# Stormwater Division

**DATE:** March 12, 2010  
**TO:** Michael J. Gillis, Virginia Correctional Enterprises Document Management Services  
**FROM:** Tina Cantwell, Stormwater  
**PO:** 270712  
**RE:** Files Approved for Scanning

Stonehosue Commerce Park BMP #2 - Avid Medical

ENVIRONMENTAL DIVISION REVIEW COMMENTS  
AVID MEDICAL EXPANSION  
COUNTY PLAN NO. SP - 127 - 01  
June 13, 2002

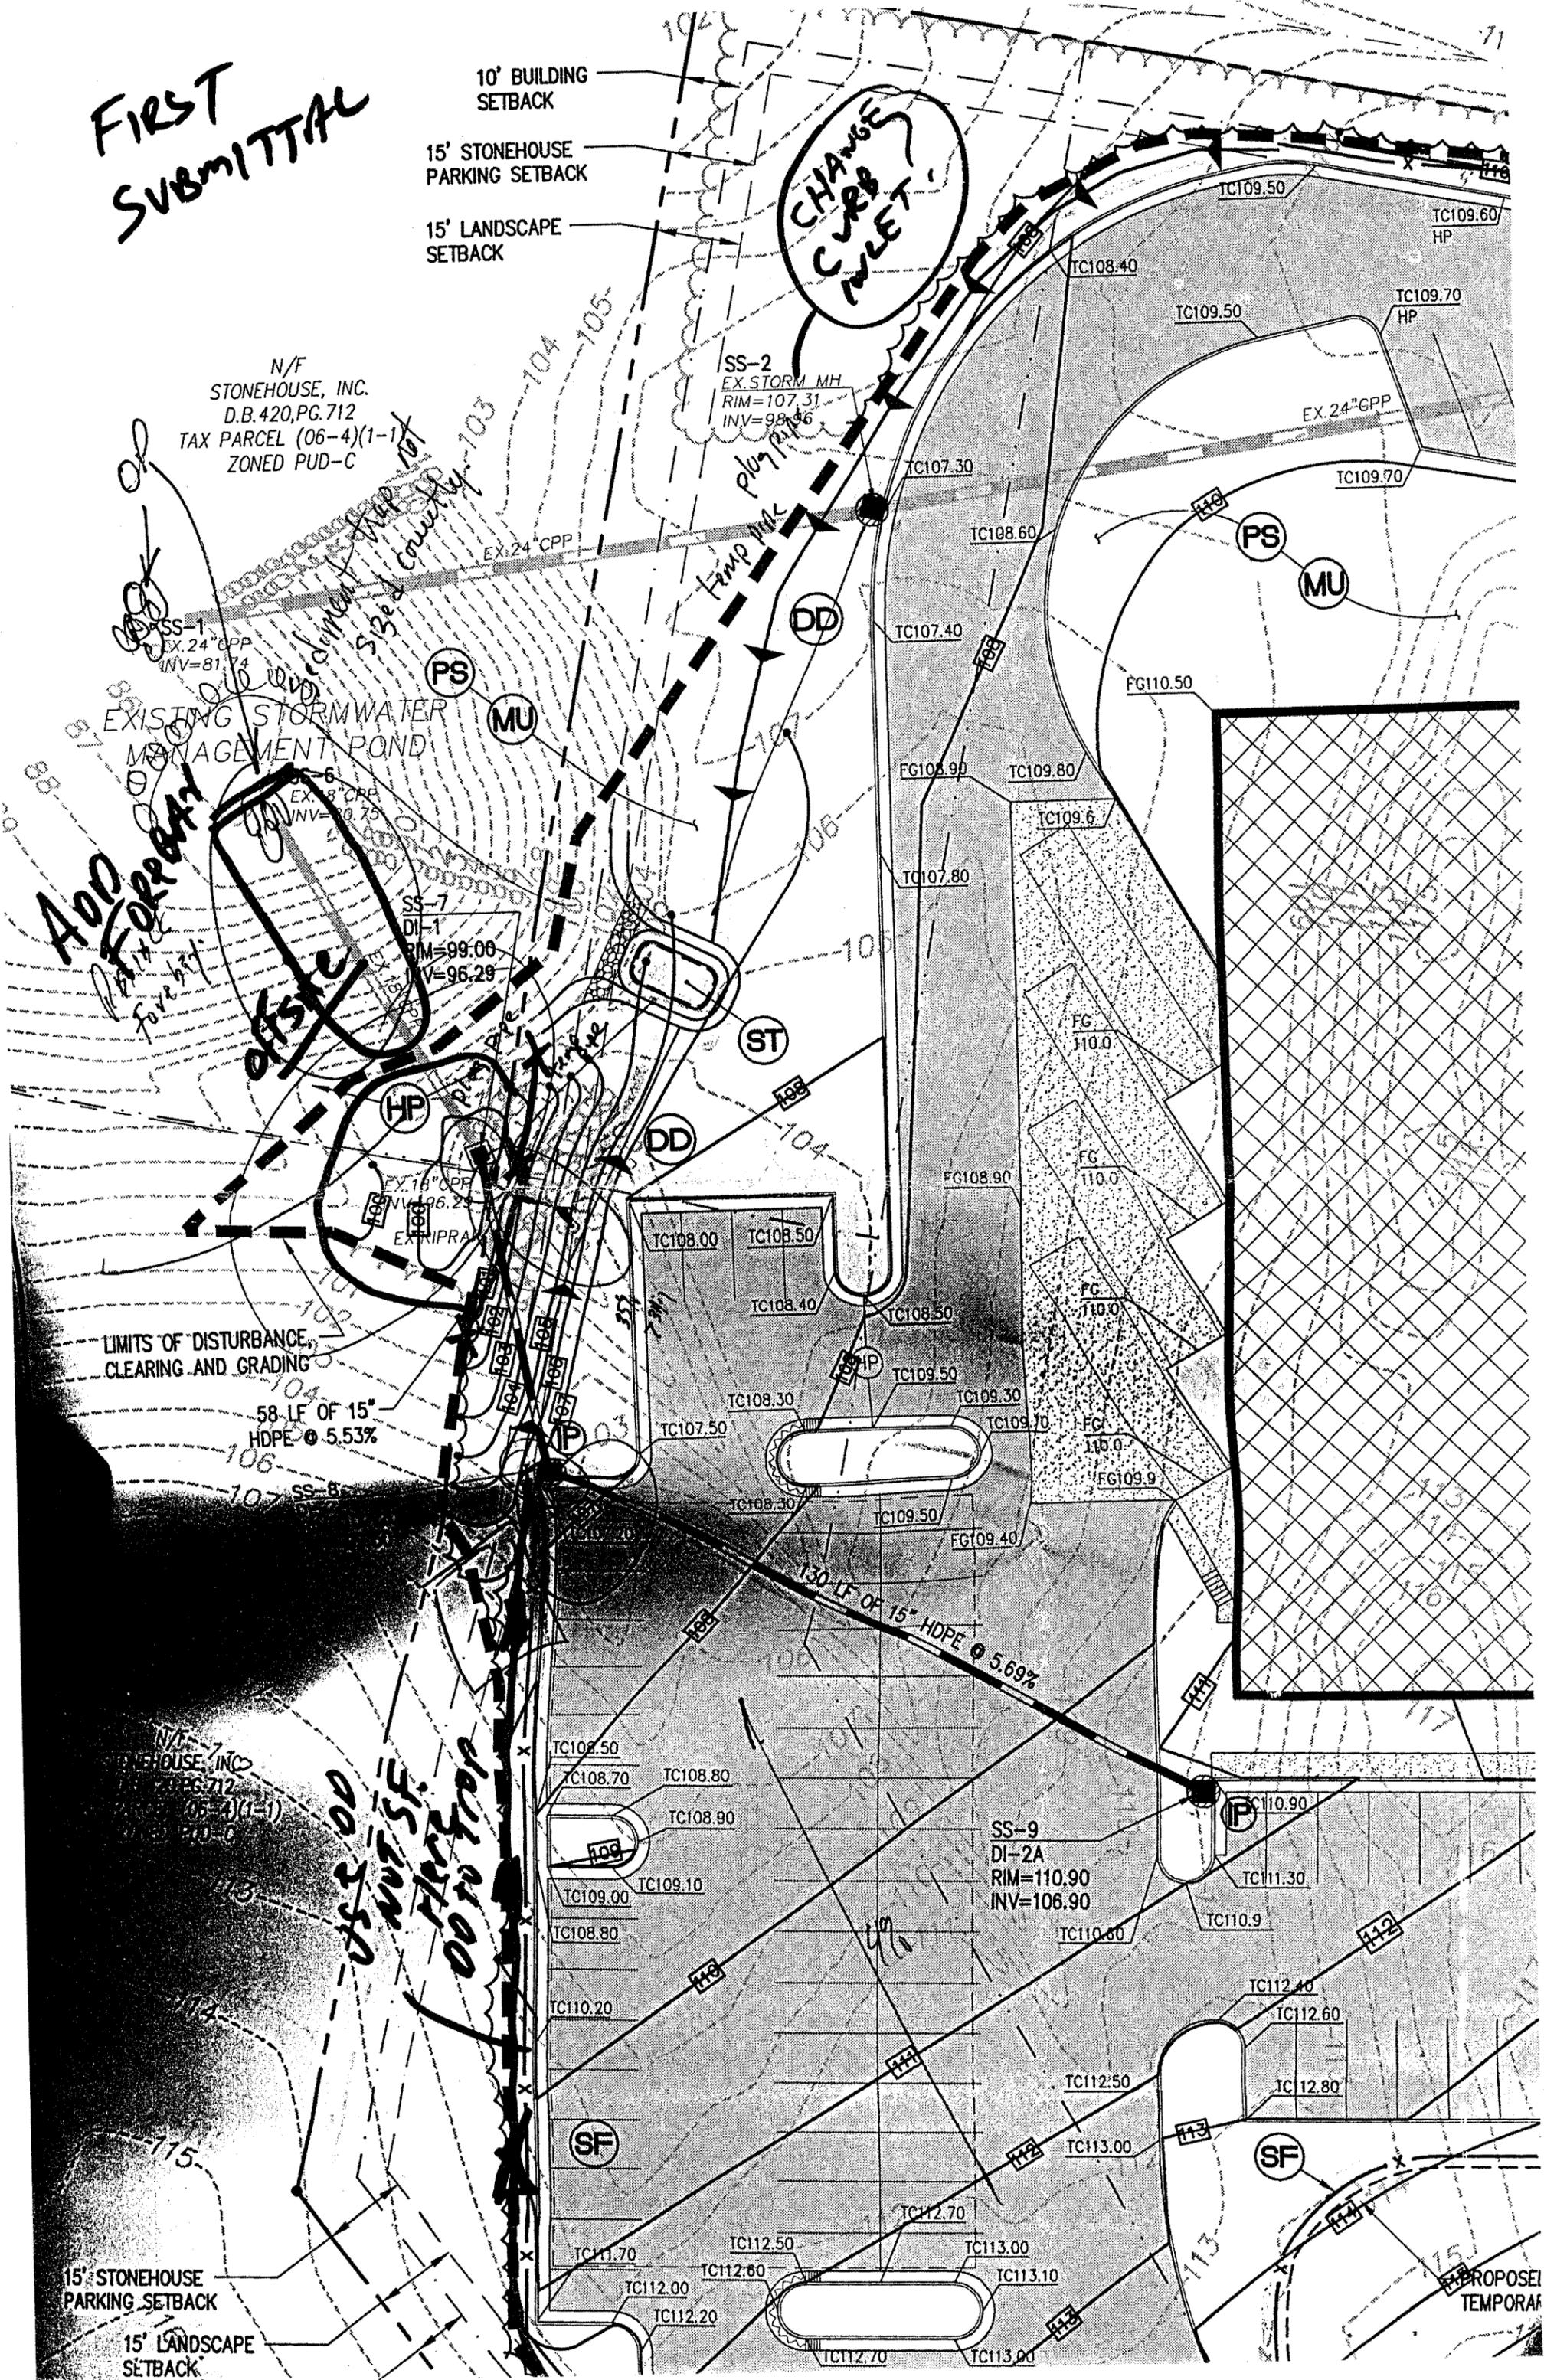
CHANGE CURB TO LET

ADD OFF-ROAD DRIVE

USE 2" HDPE  
W/UT SF  
DO NOT TRAP
